SERVICE BULLETIN

DATE: October 11, 2018 Service Bulletin No. 634
Engineering Aspects are
FAA Approved

SUBJECT: Cylinder and Head Assembly Serviceable Life

MODELS AFFECTED: All Lycoming Engines with Parallel Valve Cylinder and Head Assemblies (Table 1) shipped from Lycoming Engines between 1-SEP-2013 and 30-APR-2015 (excludes O-235 series)

Figure 1

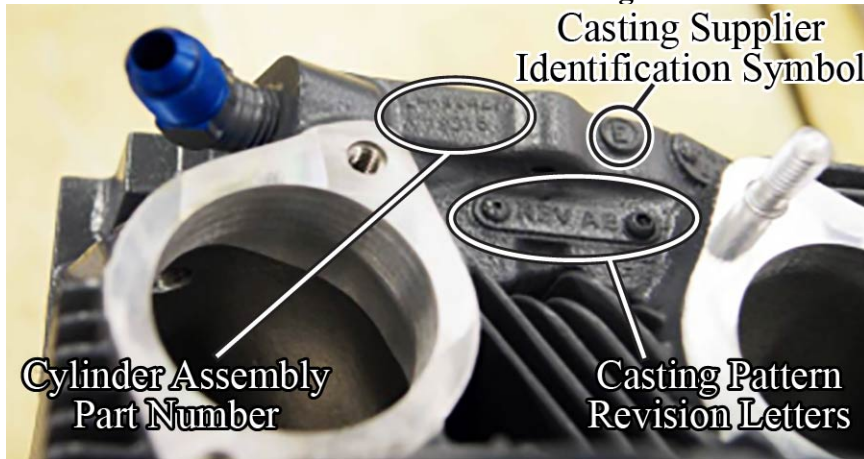
1. Refer to the casting marking locations shown in Figures 1 and 2 and find the casting markings on the Cylinder and Head Assembly.
2. Compare the casting markings to those identified for Cylinder and Head Assemblies in Table 1.

1. Do not conduct any non-Lycoming authorized repair, refurbishment, or overhaul of Affected Cylinder and Head Assemblies.
2. At overhaul of any engine containing an Affected Cylinder Head Assembly, remove, retire, and replace all Cylinder and Head Assemblies that meet the criteria of Table 1.
